Project	IEEE 802.16 Broadband Wireless Access Working Group < http://ieee802.org/16 >
Title	Correction of RS Preamble Configuration Request (RS_Config-REQ) Message
Date Submitted	2007-05-03
Source(s)	<p>Changqin Huo, Dorin Viorel, Aram Sukiashyan, Chad Gilbertson, Jagan Seshadri Fujitsu Microelectronics Canada Inc.</p> <p>Mike Hart Fujitsu Laboratories of Europe Ltd.</p> <p>Peiyong Zhu, Israfil Bahceci Nortel</p> <p>Mary Chion, Kim Olszewski ZTE USA</p> <p>dviorel@fmcj.fujitsu.com; Voice: +1 403-207-6311</p> <p>mike.hart@uk.fujitsu.com; Voice : +44 (0) 20 8606 4539</p> <p>pyzhu@nortel.com Voice: +1 613 763-1315</p> <p>mchion@zteusa.com</p>
Re:	Call for Technical Comments regarding IEEE Project P802.16j (IEEE 802.16j-07/013r2)
Abstract	In this contribution, we propose a correction of RS preamble configuration request to avoid the problem of low power-amplifier (PA) efficiency at a RS
Purpose	To incorporate the proposed change into the P802.16j Baseline Document (IEEE 802.16j-06/026r3)

Correction of RS Preamble Configuration Request (RS_Config-REQ) Message

Figure 1 Cell coverage area augmentation due to power amplifier power amplifier input backoff factor

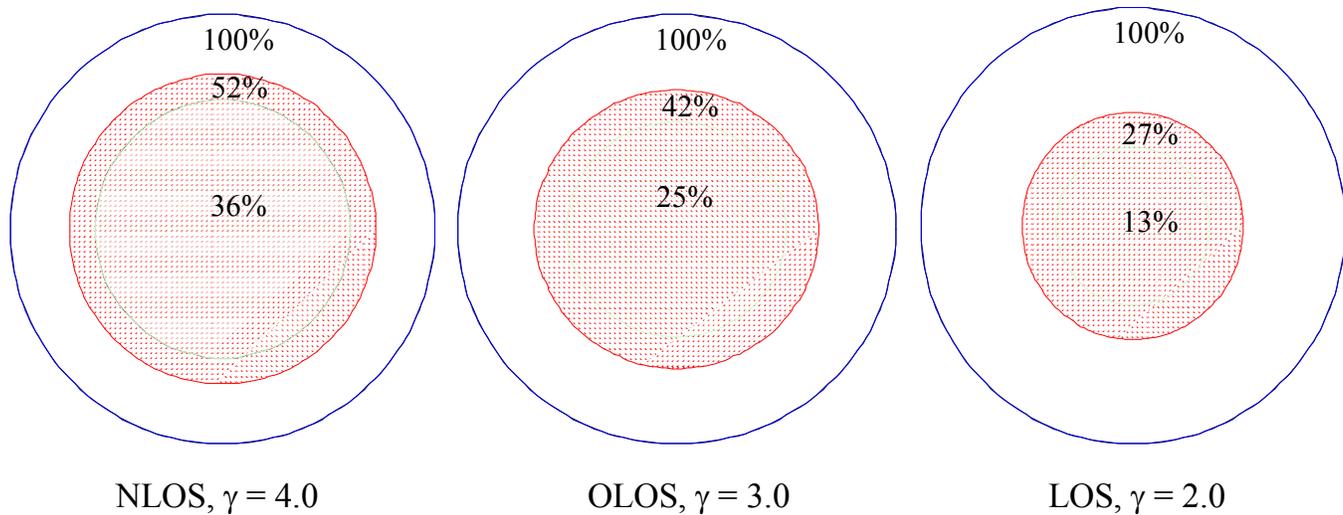
This increase in the back-off RF power factor is unacceptable due to lower power amplifier efficiency at the RS and poor relay performance at RSs caused by the lower transmit power available for each segment (assuming amplifier size remains unchanged). Figure 1 depicts the RF coverage shrink effect due to the power backoff for N_Preamble of 2 and 3 when the path loss exponent γ is 4, 3 and 2, respectively. It is seen that the coverage area approximately shrinks by 58% and 75% for N_Preamble of 2 and 3, respectively, at γ of 3 (a typical value for obstructed LOS wireless environment). When γ equals 2 (LOS), the RF coverage approximately shrinks by 63% and 87% for N_Preamble of 2 and 3, respectively.

- The outer circle (annotated with 100%) corresponds to the service area covered by a one preamble related transmitting RF power
- The first inner circle (pattern filled) represents the 2 preamble coverage area, referenced to the same initial transmitted (one preamble) RF power
- The inner circle represents the 3 preamble coverage area, referenced to the same initial transmitted (one preamble) RF power
- The 1k FFT case is analyzed, considering the input back off factor degradation presented in Table 1, for 2 and 3 preambles referenced to the one preamble transmission situation

The multiple preamble transmission at a single RS shall not be supported. In other words, N_Preamble shall be 0 (transparent mode) or 1 (non-transparent mode).

Figure 3 Two simultaneous preambles transmission impact over the spectrum of a RF PA (see assumptions) against a WIMAX 2.5 GHz spectrum mask

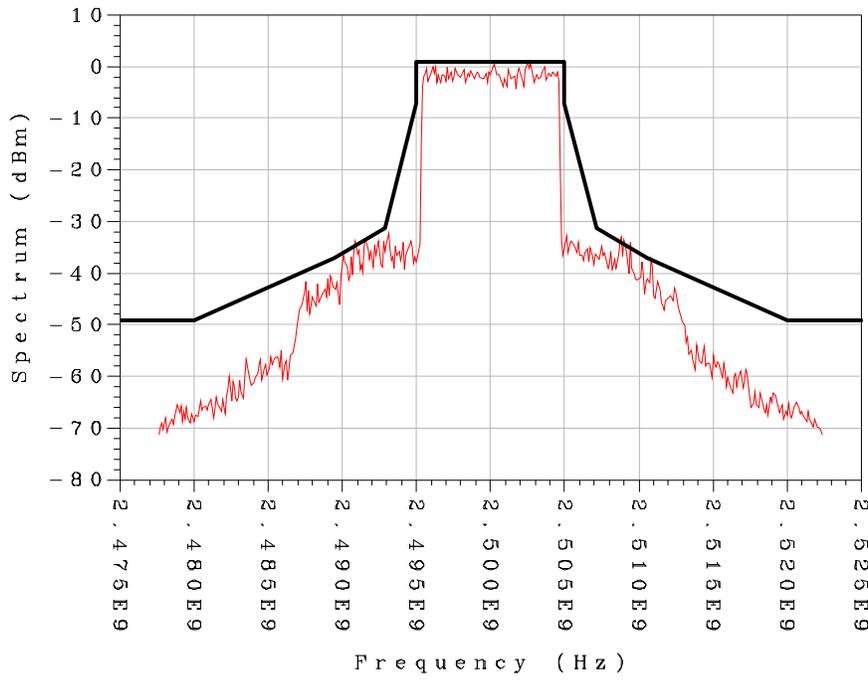
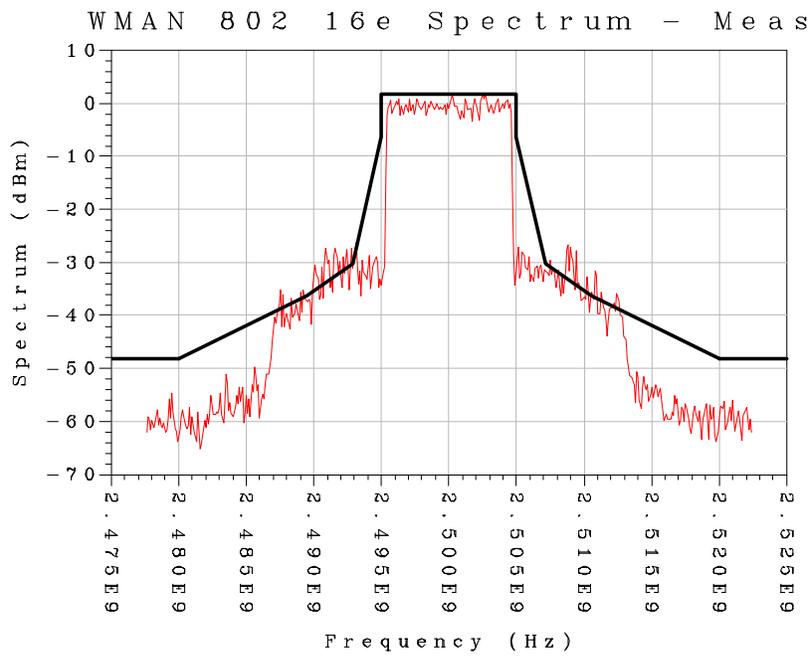
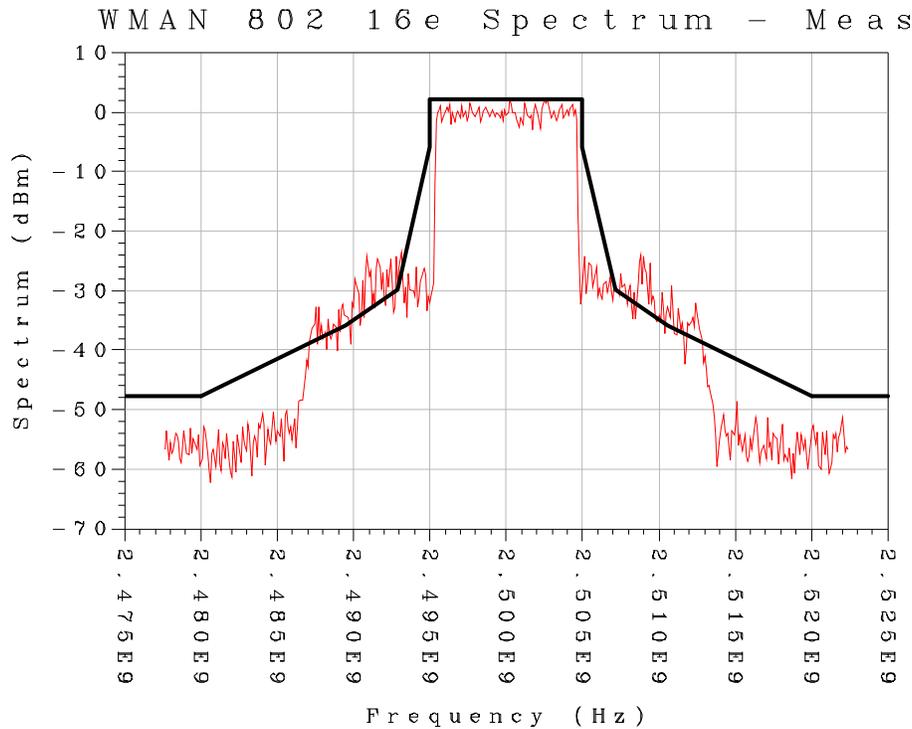
Concluding the simulations presented in Fig.2, 3 and 4, it appears that a multiple preamble 802.16j frame structure would require a different WIMAX spectrum mask than the actually pre-approved one. Therefore the 802.16j RSs would require a different spectral mask than the (expected to be) certified 802.16e BS spectral mask.
